LINE	QUANTITY	UOP	CAT NO	ITEM NUMBER	UNIT PRICE	AMOUNT
ADDENDUM NO.02						
ADDENDUM FOR THE RENOVATIONS TO THE WEST VIRGINIA VETERANS MEMORIAL LOCATED IN CHARLESTON, WEST VIRGINIA AT THE CAPITOL COMPLEX ISSUED TO DISTRIBUTE THE ATTACHED INFORMATION TO THE VENDOR COMMUNITY.						
0001	1	LS	968-42	RENOVATIONS TO WV VETERANS MEMORIAL		
***** THIS IS THE END OF RFQ GSD146406 ***** TOTAL:

SOLICITATION NUMBER: GSD146406  
Addendum Number: No.02

1. Modify Price and Payment section, Section 01200
2. Re-issue drawings C101, A101, A102, A201, A501, A502.
3. Publish Vendor Questions and Agency Response.
4. Revised Pricing Pages
5. Move Bid Opening date from: February 04, 2014 at 1:30 PM. EST.  
to: February 11, 2014 at 1:30 PM. EST.
6. No other changes.

**C101**

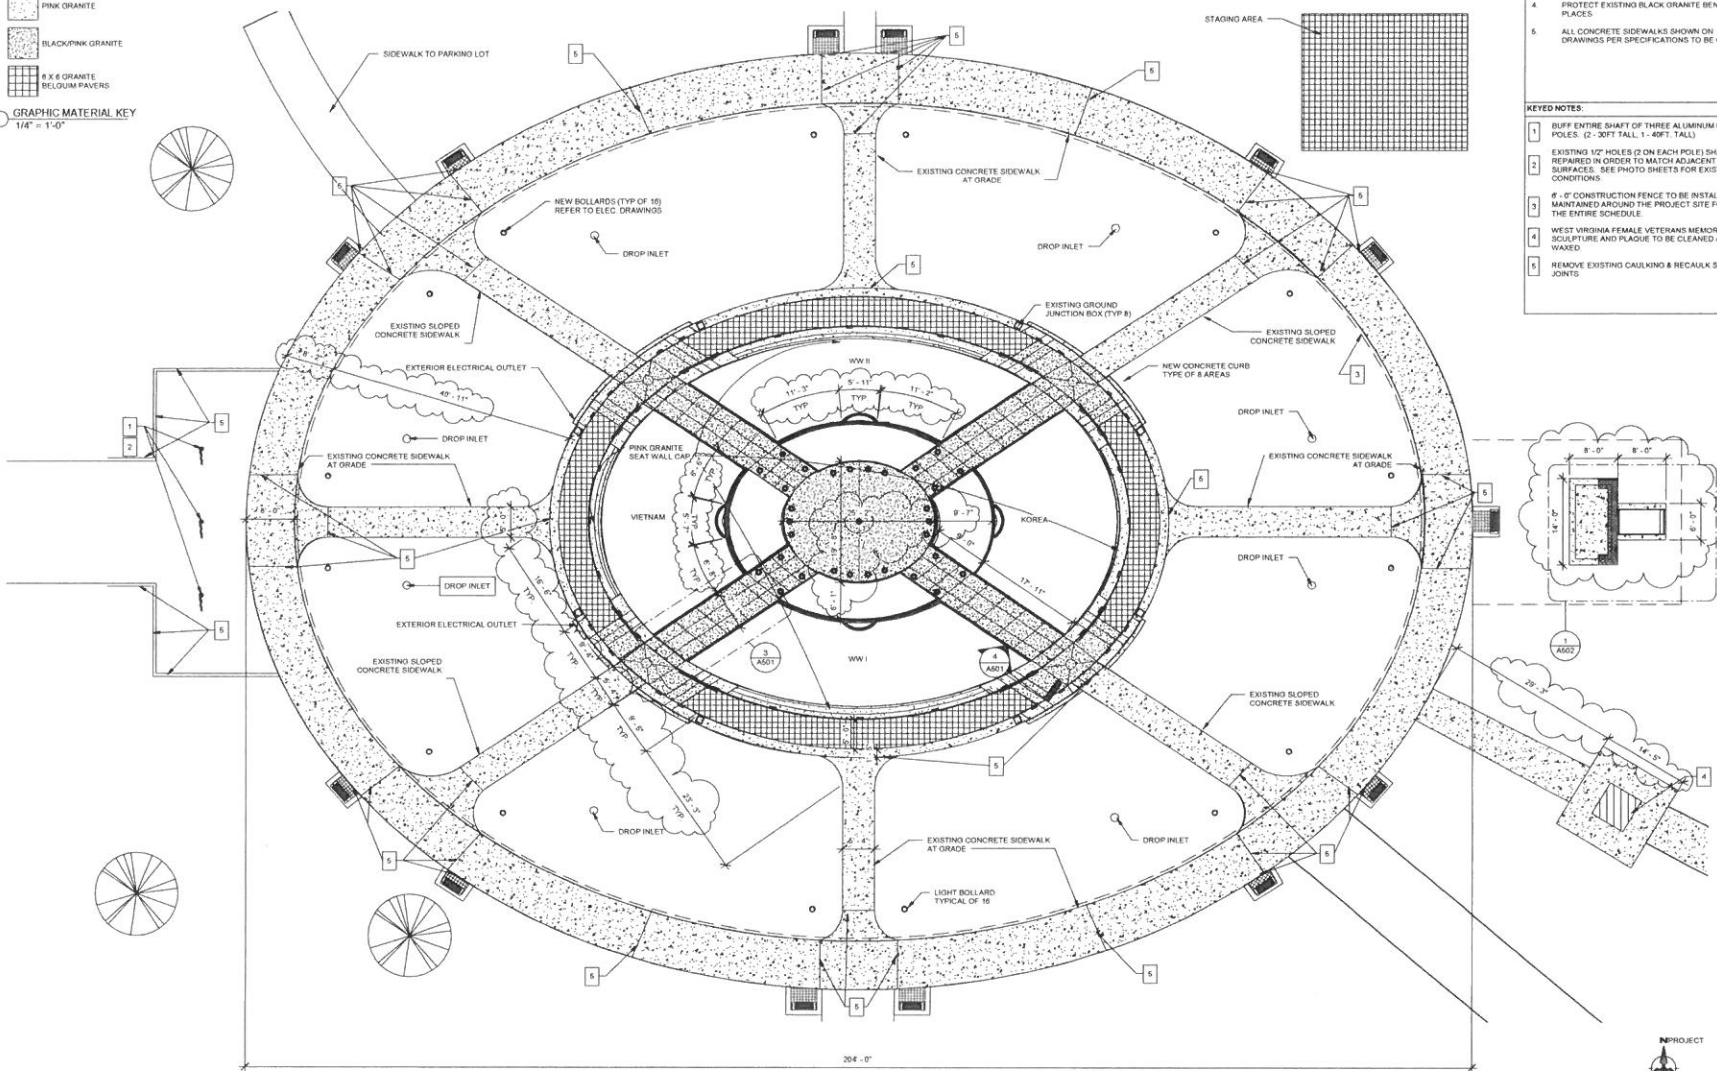
10. Refer to sheet CN, General Notes; Note 5 indicated not to scale drawings. Please provide dimension plan.

11. Refer to C101, Staging Area; will a sufficient space be provided for a field office trailer, storage trailer and parking?

*A.10. Please see sheets C101 and A201 with Revision #1 noted and dated 1/24/14 with added dimensional information.*

*A.11. An office trailer is not allowed on site. The Contractor will have room for one or two small (less than semi-size) storage trailers, limited employee parking will be away from the veteran memorial site on campus as directed by the General Service Administration.*

**A101**  
 Scale As indicated

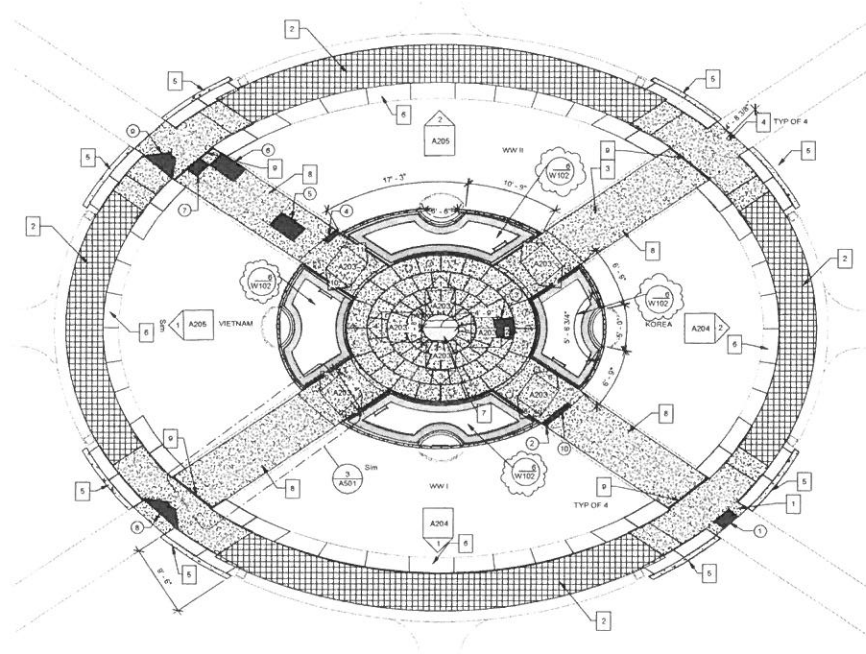
Granite Paver Replacement - Base Bid includes 10 pieces as detailed on sheet A101 for a total of 500 square feet (of the total of approximately 1170 Square feet, 670 square feet is assumed to not require replacement). If the actual quantity differs from the quantity included in the Base Bid,

**A501**

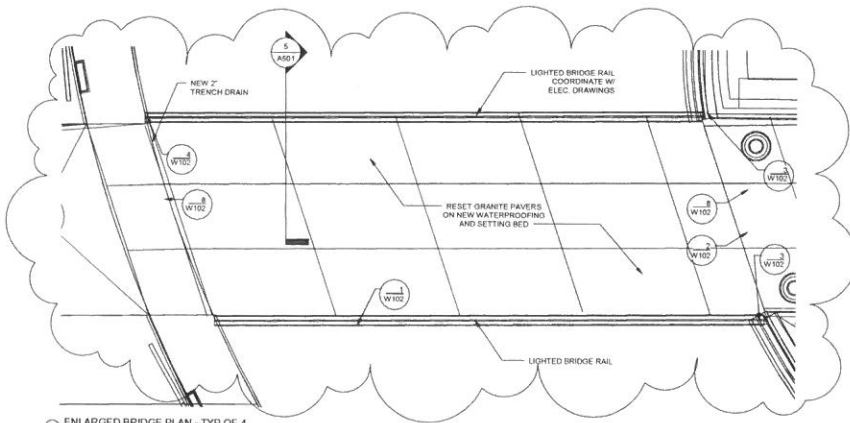
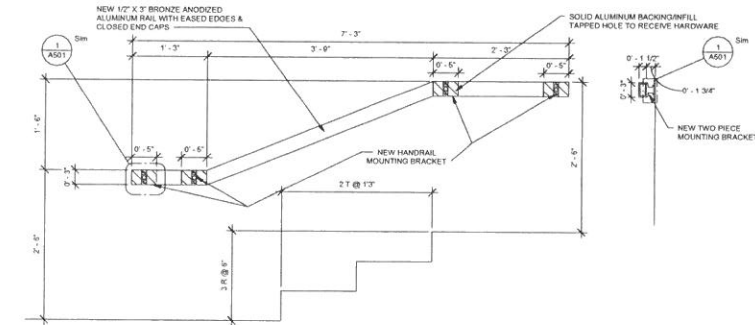
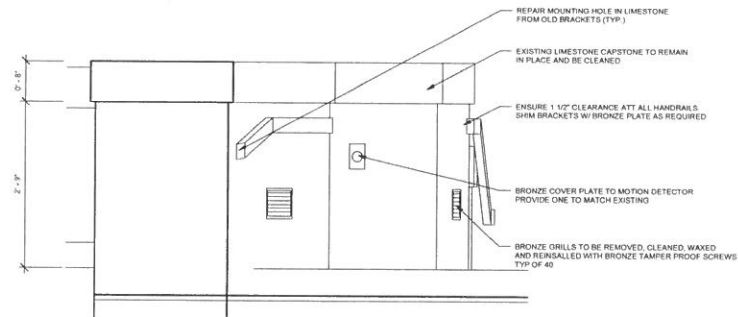
12. Refer to sheet A501, Detail 1, 2 & 4; please clarify how many new handrails are to be provided and if the new handrails are to tube type plate type. Note, the dimension given in detail 2 is ½" X 3", but it shown as a tube.

13. Refer to sheet A501, Detail 5, "Re-anodize exposed base cove components"; according to one anodizing company, existing pieces that have weathered for years will not accept anodizing like new material and therefore will not match the existing pieces (top rail) and may not match from piece to piece. Is this acceptable?

*A.12. There are a total of eight handrails of the same configuration and size. The correct size of the new handrails shown in detail 2 should read as 1-1/2"x3"tube.*

*A.13. The contractor should include the re-anodizing of the base cove and handrail components as illustrated on sheet A501 and in Detail 5. A unit price has been added to the bid form to allow for the replacement of the bronze anodized components in kind if the mock ups for the restoration efforts are deemed unacceptable by the owner and architect.*
